**CITY OF HANOVER
PLANNING COMMISSION MEETING
OCTOBER 24, 2016**

Date: October 20, 2016
To: Planning Commission
From: Cindy Nash, City Planner
RE: J.S. Stewart Companies – Site Plan

Re: *JS Stewart Companies Site Plan Review*
WSB Project No. 02082-013

Re: *Hanover Public Works Facility Site Plan Review*
WSB Project No. 02082-013

Sheet C5 – Details

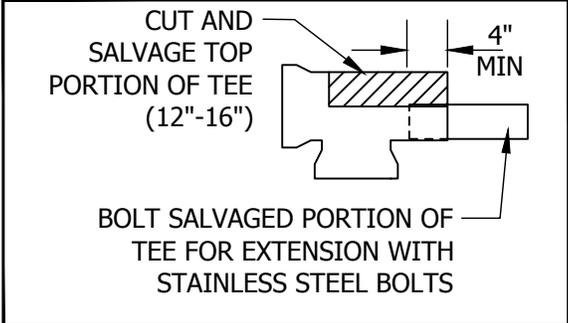
1. Include the attached detail for sanitary sewer inside drop inlet manhole.

ALL PIPES SHALL BE CUT TO BE 2" INSIDE MANHOLE AT THE PIPE'S MIDPOINT AND HAVE A WATER TIGHT SEAL. (SEE SPECIFICATIONS)

ALL DOG HOUSES SHALL BE GROUTED ON THE INSIDE AND OUTSIDE.

Storm Design

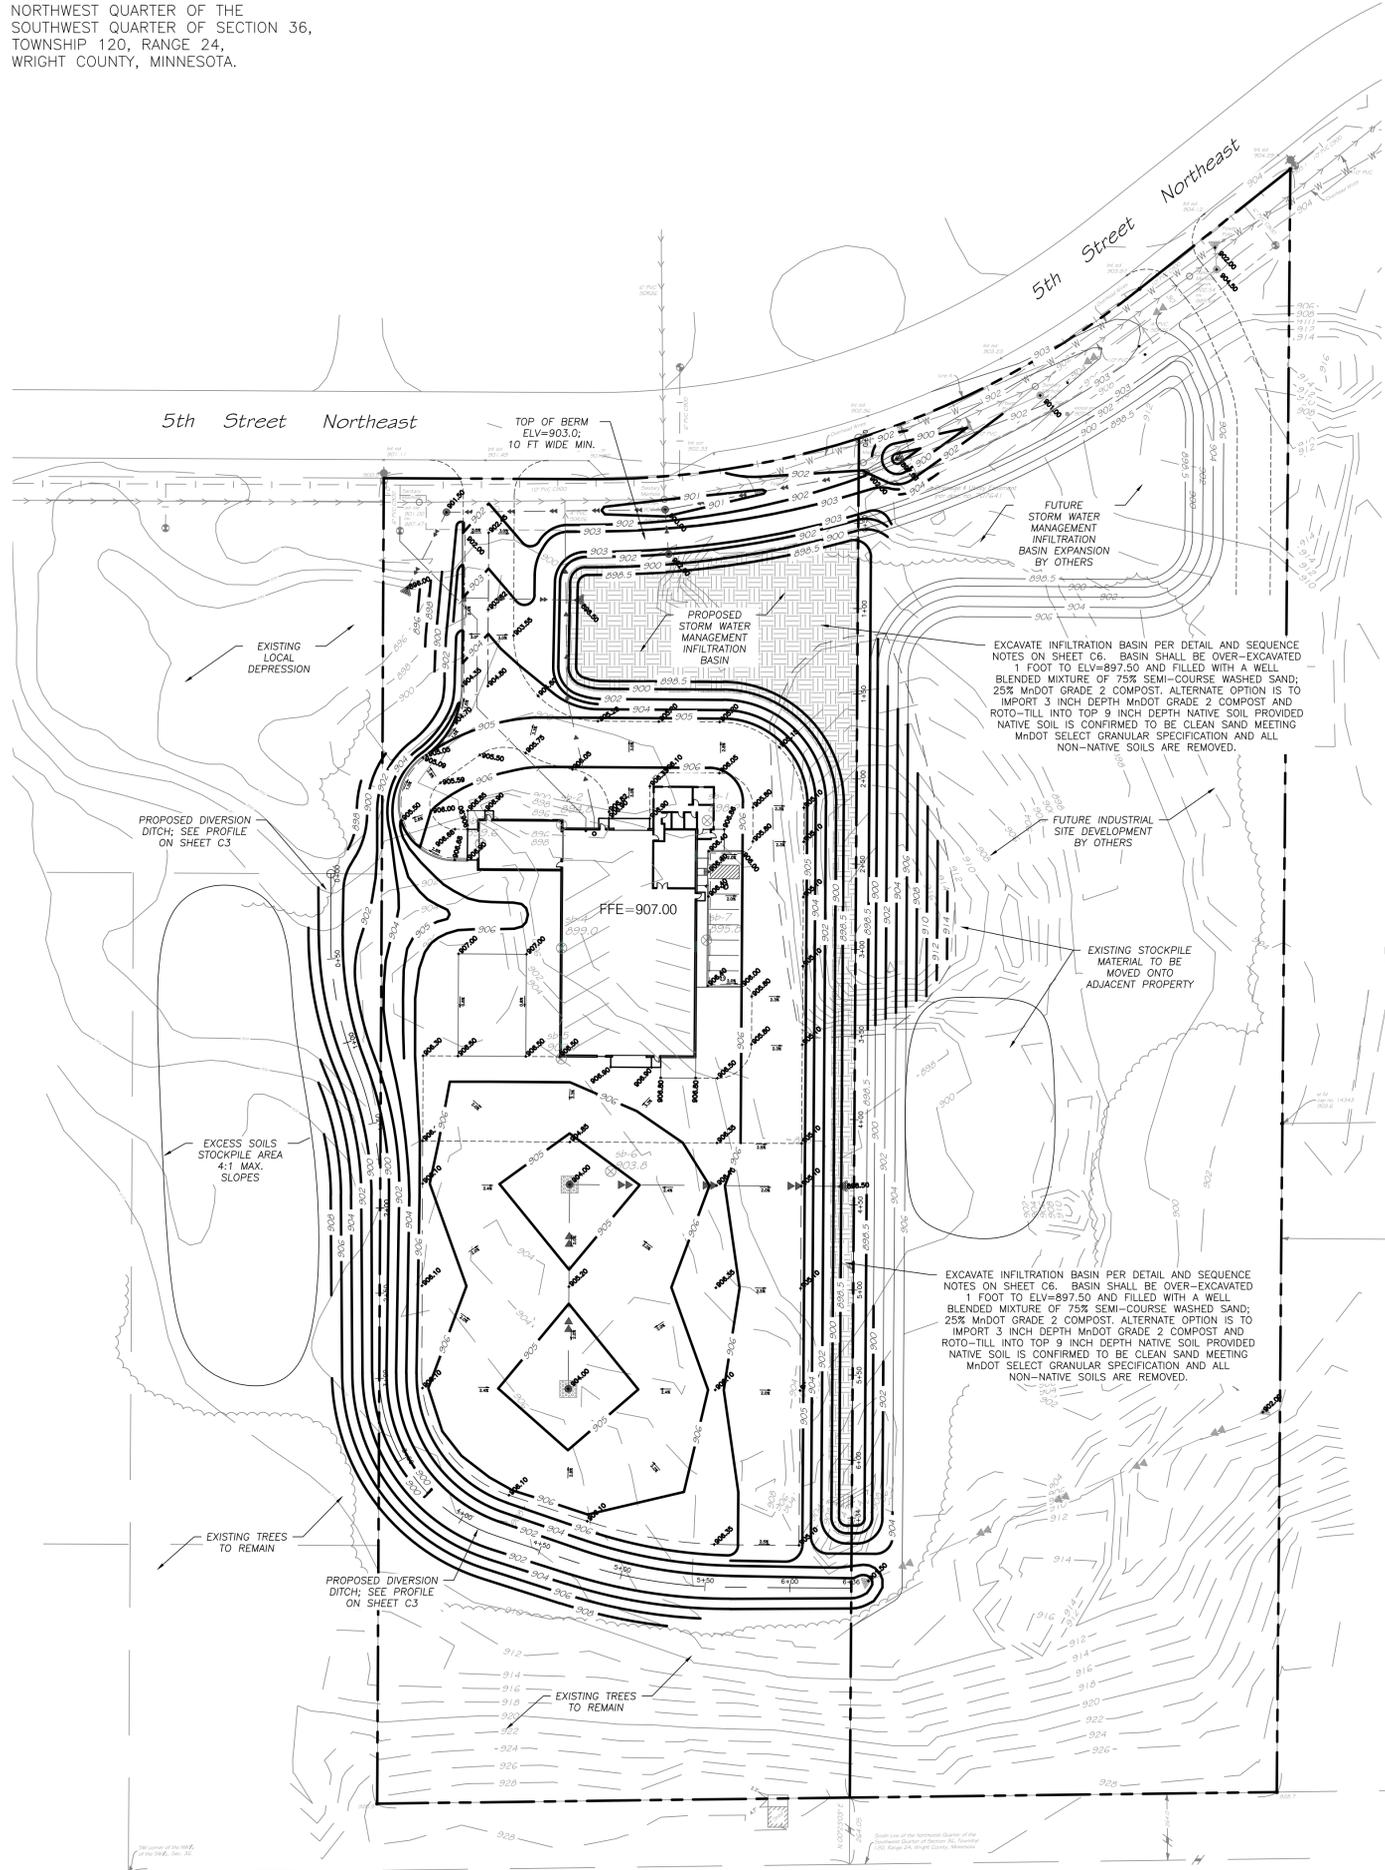
- The current swales are proposed at a grade of 0.2%. Care should be taken during construction to ensure there is at least 0.2% to help minimize the likelihood of standing water.
